GJS Plot F, Manchester

Tower F2 - Podium Design | 26.02.2024
F2-SHP-A180-RP-XX-B5D803 | P02

PLANNING CONDITION 19

Fig 1 - F2 - Consented south west elevation drawing
Fig 2 - F2 - Consented south east elevation drawing

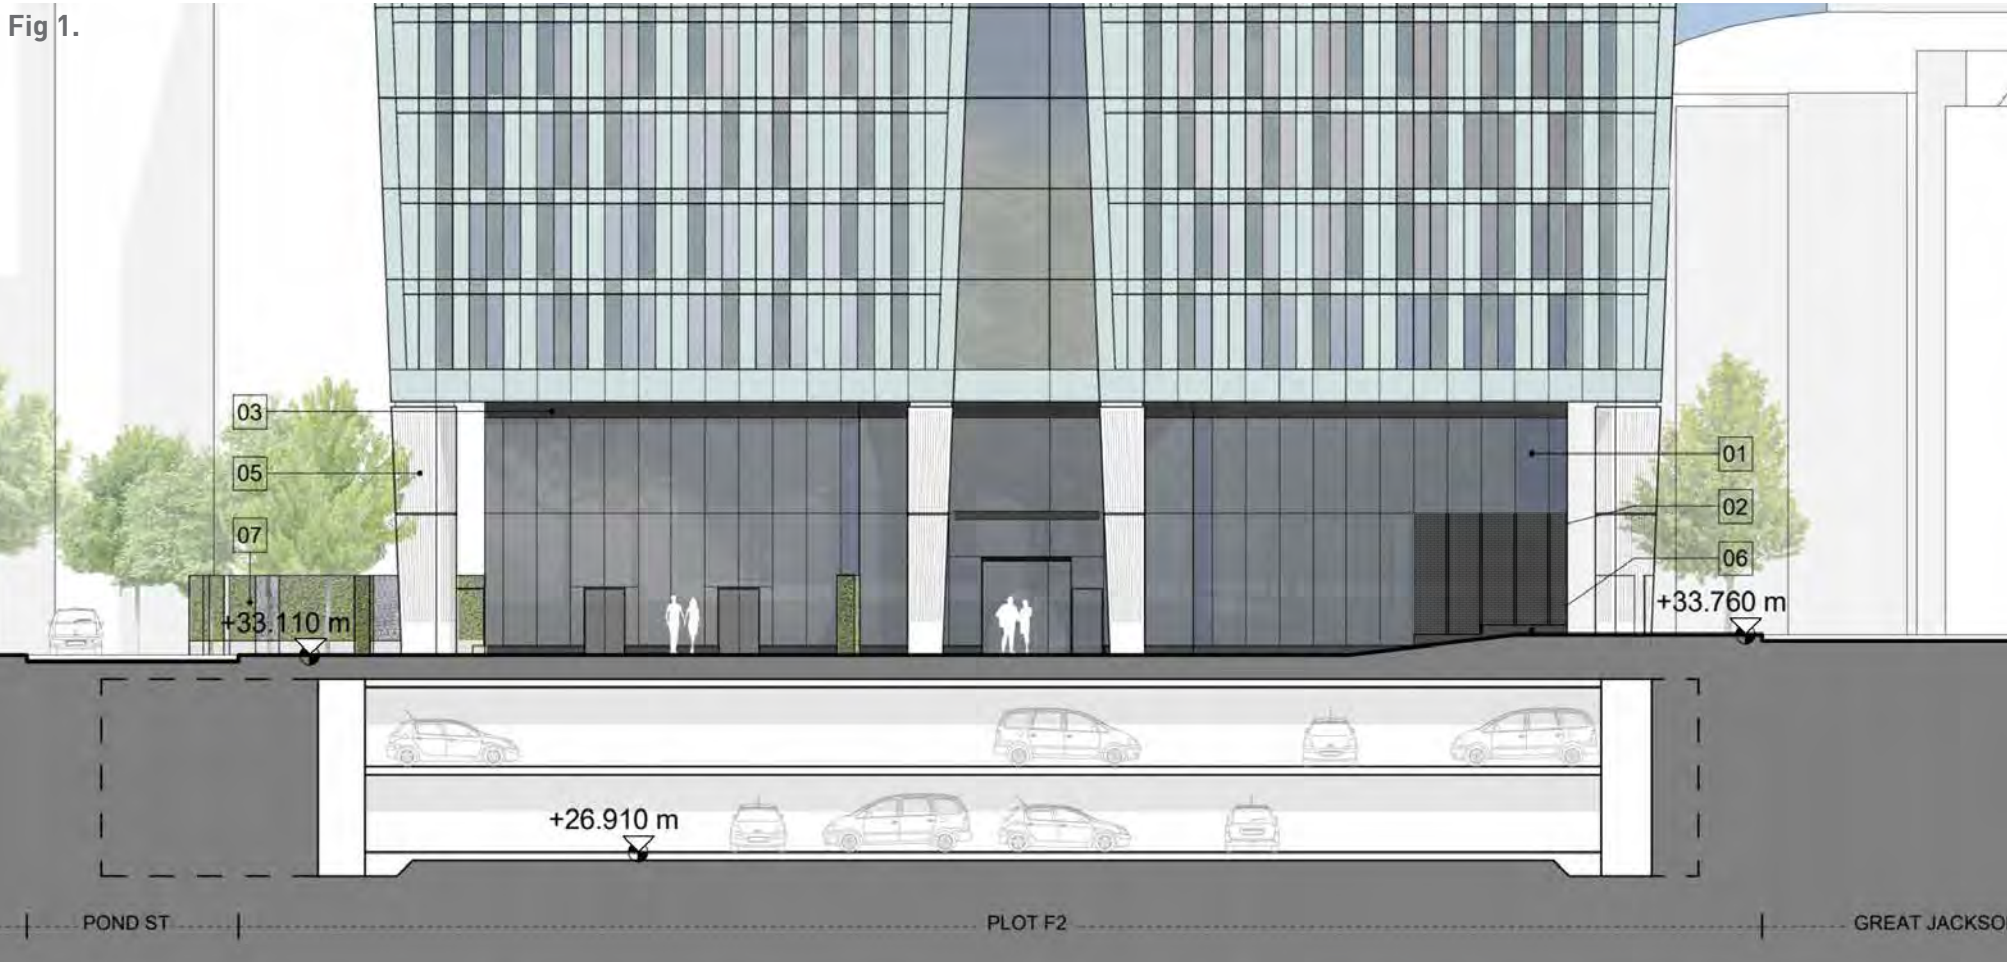
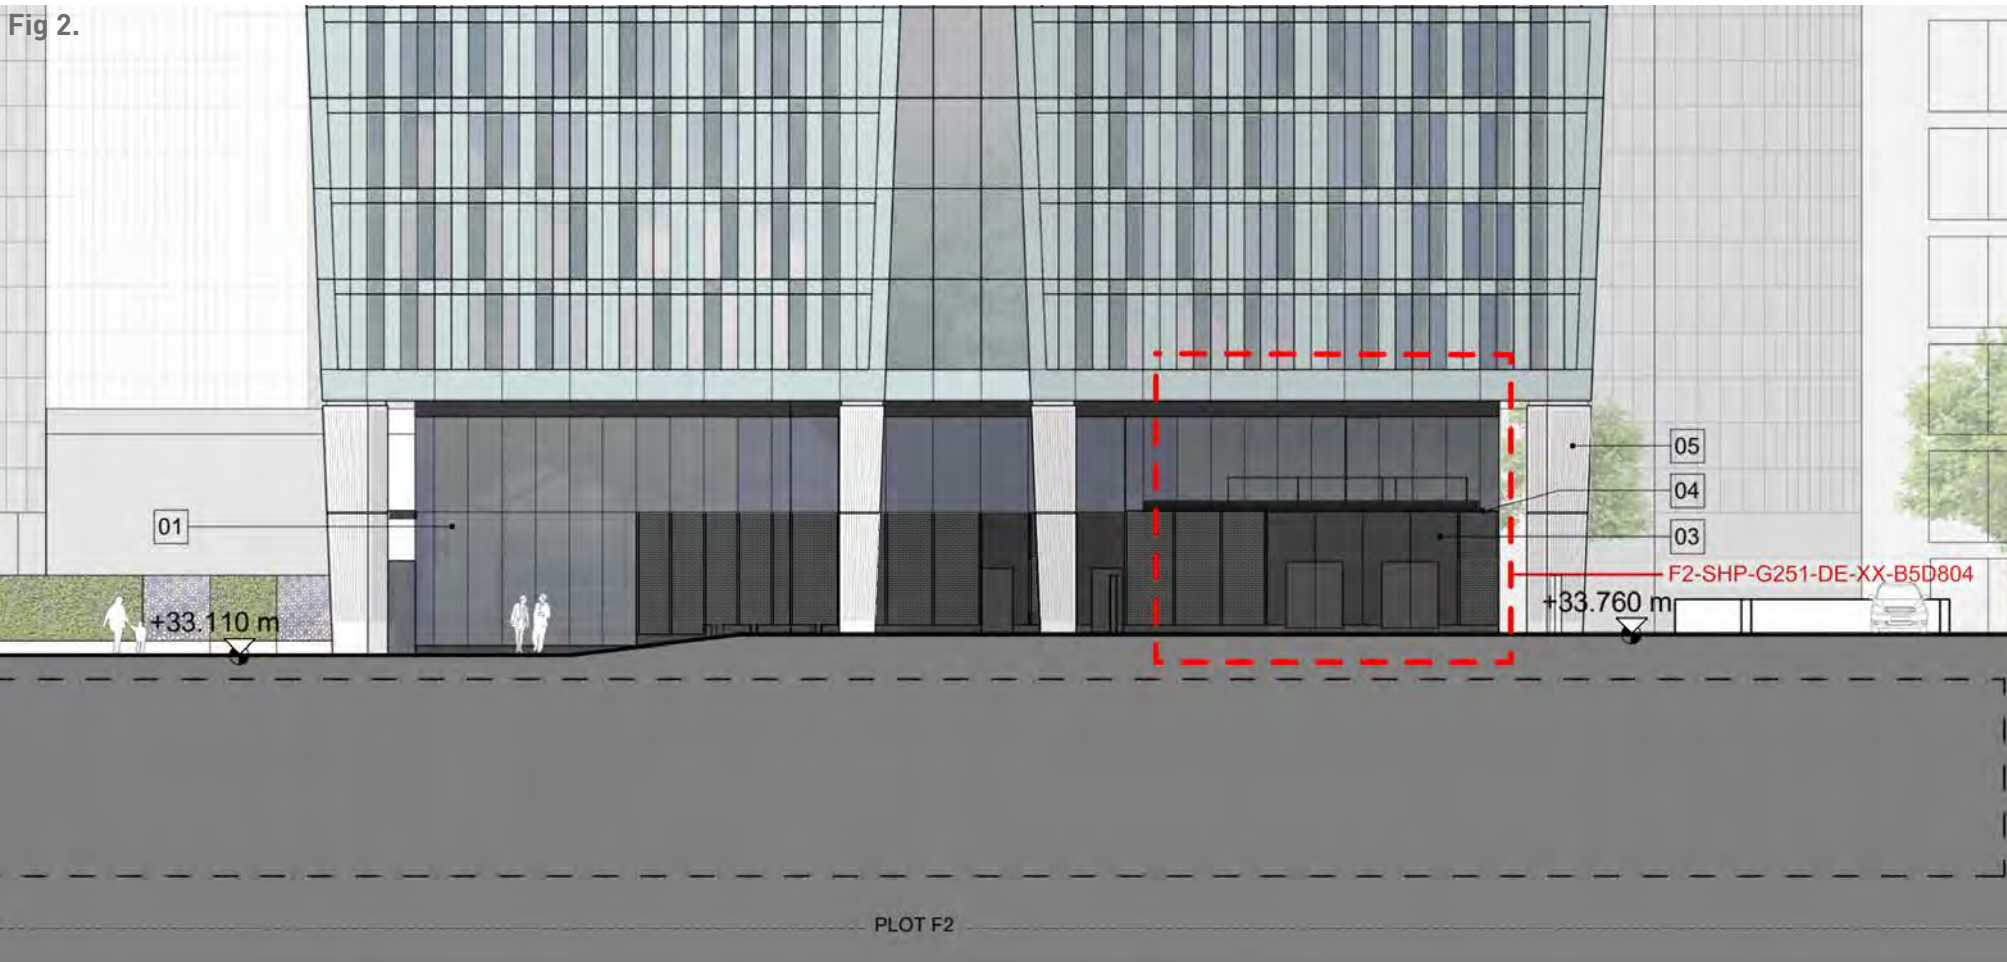
Further to the above application, I note that there are large areas of louvres proposed for the ground floor elevations where there are plant and waste storage rooms. As these areas front onto pedestrian thoroughfares and will be highly visible, please would you look at using anodised aluminium decorative screening (eg to match the purge vents on the floors above) instead of, or to screen, the large areas of louvres.

In direct reponse to the feedback from MCC, the design team have considered the implications of the introduction of perforated screens at ground floor from both an aesthetic and technical perspective.

A band of louvres at level 01 soffit ahs been kept in the design as it is a key element for the articulation of the podium and the tower above.
